This letter is intended to serve as a comment response letter for the Amara Annexation, Master Plan, and Zoning initial review of the above requested application dated January 25, 2022. This letter is to accommodate the requested resubmitted plan and documents associated with the application.

**RE: Amara (Annexation, Mater Plan and Zoning) - Initial Review Comments**  
**File: CPC A 21-00197 - CPC A 21-00207, CPC MP 21-00208, CPC ZC 21-00209**

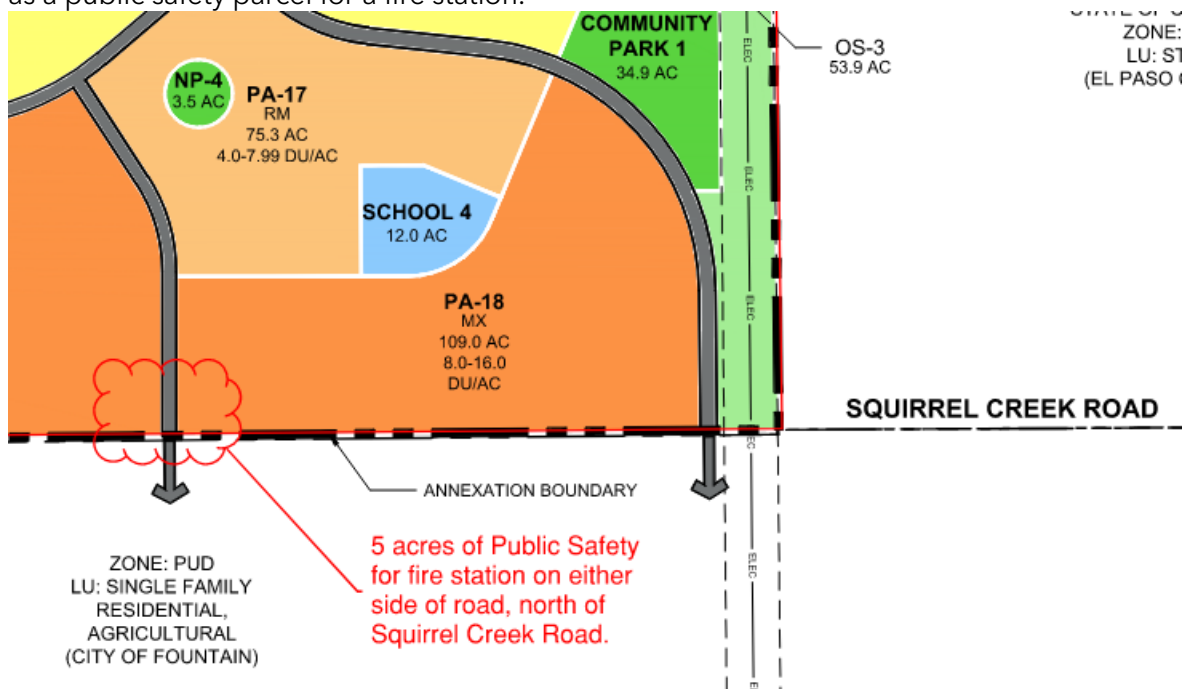
1. Include the FEMA floodplain note with the current map numbers and series.
  - **Response: A portion of this site (Jimmy Camp Creek) is located within a 100-year floodplain as determined by the Flood Insurance Rate Maps (F.I.R.M.) Map Number 0841C0958 G with an effective date of December 7, 2018 (See Appendix). The affected area is located within the studied main channel of Jimmy Camp Creek. Developed storm water release into Jimmy Camp Creek shall be in accordance with all appropriate agencies and FEMA floodplain regulations. A Floodplain Development Permit will be required to support construction areas within the existing 100-year floodplain. Where possible floodplain preservation will be strictly adhered to, to preserve the corridor and minimize /eliminate FEMA engagement.**

The easterly portion of the site is located within the Upper Williams Creek Basin that contains a FEMA Zone A floodplain. Prior to any development within 300' of the Zone A floodplain, FEMA approved base elevations are required to be determined on all plats, or a Floodplain Certification Letter by a professional engineer be provided.
